Staff comments:

01 SITE PLAN
1" = 50'-0"

DISD - W.W. BUSHMAN REPLACEMENT ELEMENTARY SCHOOL

ZONING CASE # Z 212-271

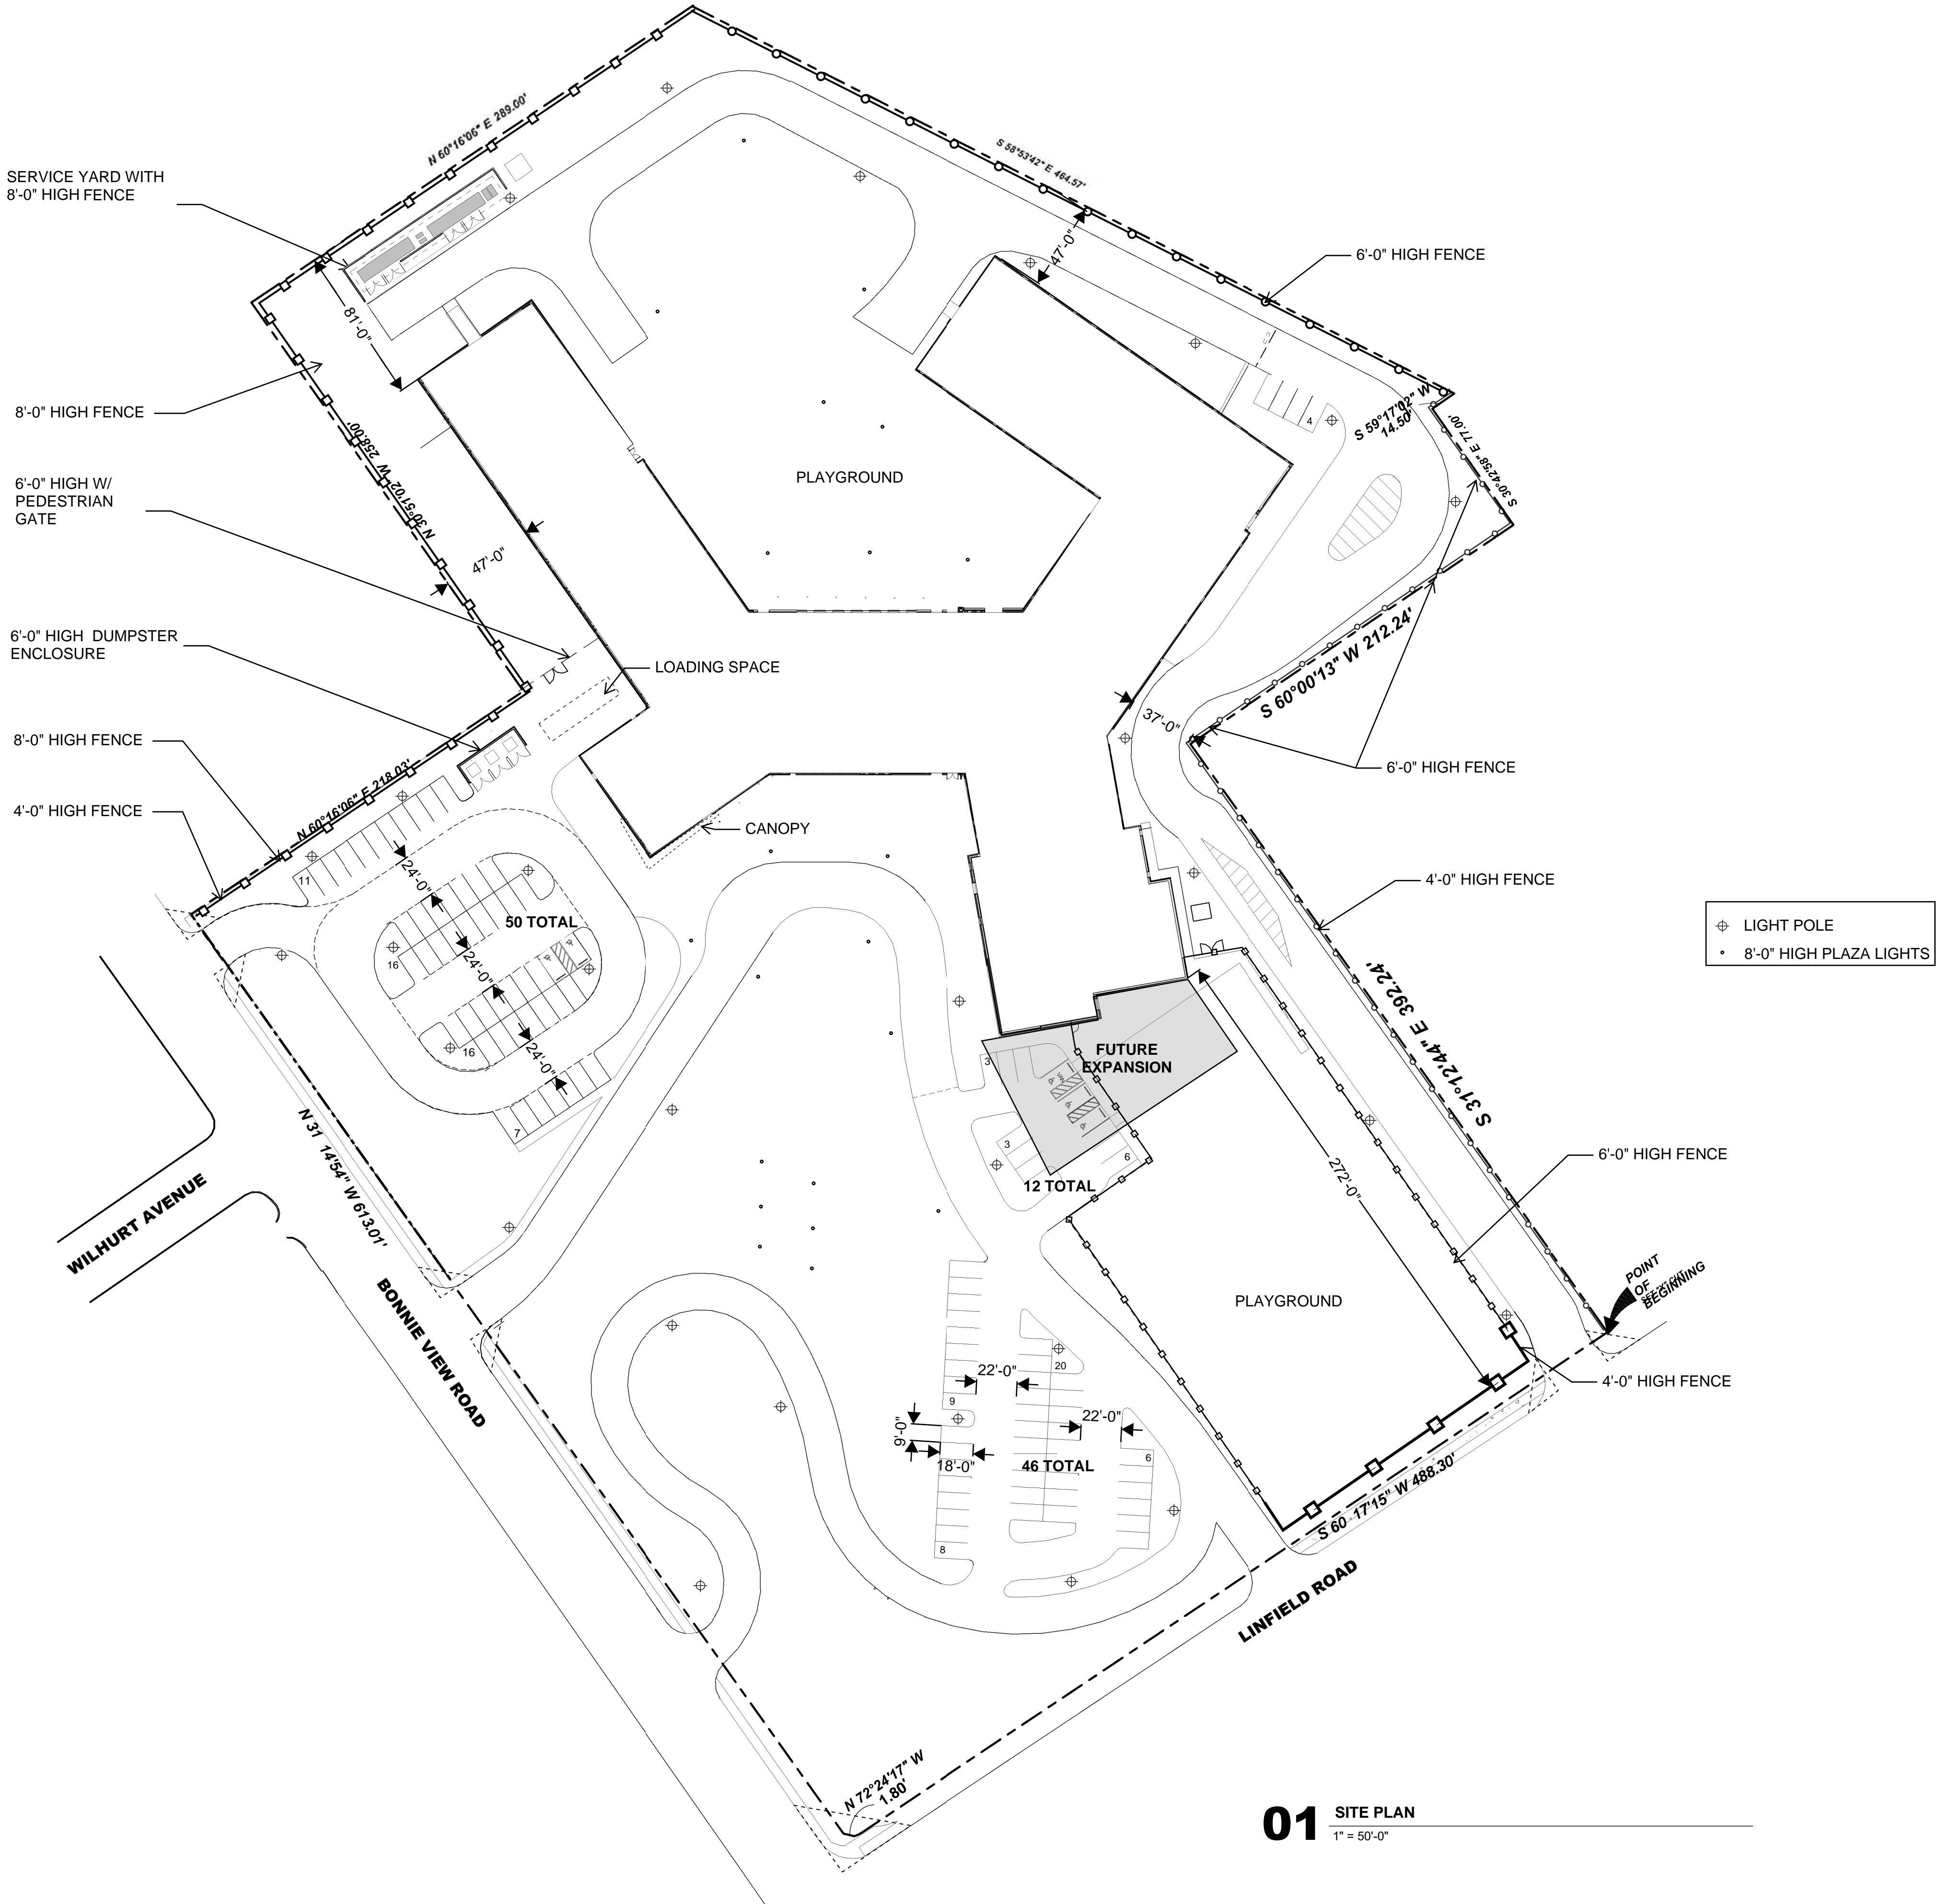
1. ADD THE FOLLOWING TO THE DATA TABLE:
-> NUMBER OF LOADING SPACES REQUIRED
-> PARKING RATIO
-> NOTE INDICATING LOCATION OF BICYCLE PARKING SPACES TO BE DETERMINED AT PERMITTING.

2. TABLE HAS INCORRECT DATA.
-> CONFIRM THE MATH AND CORRECT THE DATA.
3. SHOW SIDEWALK/BUFFER FULL LENGTH OF ALL STREET FRONTAGES AND ADD NOTE:
"MINIMUM 6'-0" WIDE SIDEWALK w/ MINIMUM 5'-0" WIDE BUFFER MUST BE PROVIDED ALONG THE ENTIRE LENGTH OF ALL STREET FRONTAGES, TYP."

- "NOTE: 5'-0" WIDE SIDEWALK IS MINIMUM REQUIRED FOR ADA COMPLIANCE; HOWEVER, STAFF RECOMMENDS MINIMUM 6'-0" WIDE SIDEWALKS AT SCHOOLS. OTHER PEDESTRIAN AMENITIES SUCH AS BENCHES, TRASH CANS, AND PEDESTRIAN SCALE LIGHTING ARE RECOMMENDED AT REGULAR INTERVALS ALONG STREET FRONTAGES, HOWEVER, THESE ITEMS ARE NOT CURRENTLY REQUIRED BY CODE.

4. SHOW VISIBILITY TRIANGLES AT ALL POINTS OF INGRESS/EGRESS, AND REVISE PLAN TO REMOVE VISIBILITY OBSTRUCTIONS.
5. EXTEND THROAT OF DRIVEWAY ON LINFIELD TO AVOID ABRUPT TURN SINCE DESIGN DOES NOT PHYSICALLY DISCOURAGE WRONG WAY TURNS.
-> TMP DOES NOT SHOW THIS DRIVEWAY AS ONE-WAY OPERATIONS. NOT APPROVABLE AT PERMITTING AS CURRENTLY PROPOSED.

6. ADD PAVED PEDESTRIAN PATH ALONG CIRCUITOUS DRIVEWAYS AND/OR PEDESTRIAN ROUTES THROUGH THE CAMPUS FROM ALL ACCESS POINTS.
-> TMP DOES NOT SHOW ANY PEDESTRIAN RESTRICTIONS. AS CURRENTLY PROPOSED, THE DESIGN WILL NOT DISCOURAGE ACCESS TO PEDESTRIANS BUT WILL CREATE UNSAFE CONDITIONS FOR STUDENTS INSTEAD. NOT APPROVABLE AT PERMITTING AS CURRENTLY PROPOSED.

7. REVISE INTERNAL CONNECTION w/PERPENDICULAR INTERSECTION PER ENGINEERING/TRAFFIC STAFF COMMENTS.
-> SEE STAFF COMMENTS UNDER NOTE 6 ABOVE.
8. ENSURE THAT SITE PLAN AND TMP ARE CONSISTENT BEFORE SUBMITTING REVISIONS.

9. BECAUSE THE PROPERTY HAS AN APPROVED PRELIMINARY PLAT WHICH WILL BE RELIED UPON TO ESTABLISH A BUILDING SITE FOR CONSTRUCTION OF THE REPLACEMENT SCHOOL, PROPERTY LINES MUST BE SHOWN PER THE APPROVED PRELIMINARY PLAT, ADJUSTED PER CPC APPROVAL CONDITIONS.
-> SITE PLAN IS NOT APPROVABLE AS SHOWN. REVISION REQUIRED.
-> ADJUST PROPERTY LINE LOCATIONS AND DIMENSIONS PER CPC APPROVAL CONDITIONS 15 & 16 IF DEDICATIONS WILL BE FEE SIMPLE.
-> IF DEDICATIONS WILL BE VIA STREET EASEMENT, SHOW STREET EASEMENT LINES.
-> ENSURE THAT PROPOSED DESIGN MEETS SETBACK REQUIREMENTS TAKEN FROM NEW PROPERTY LINES OR FROM STREET EASEMENT LINES, AS APPLICABLE.
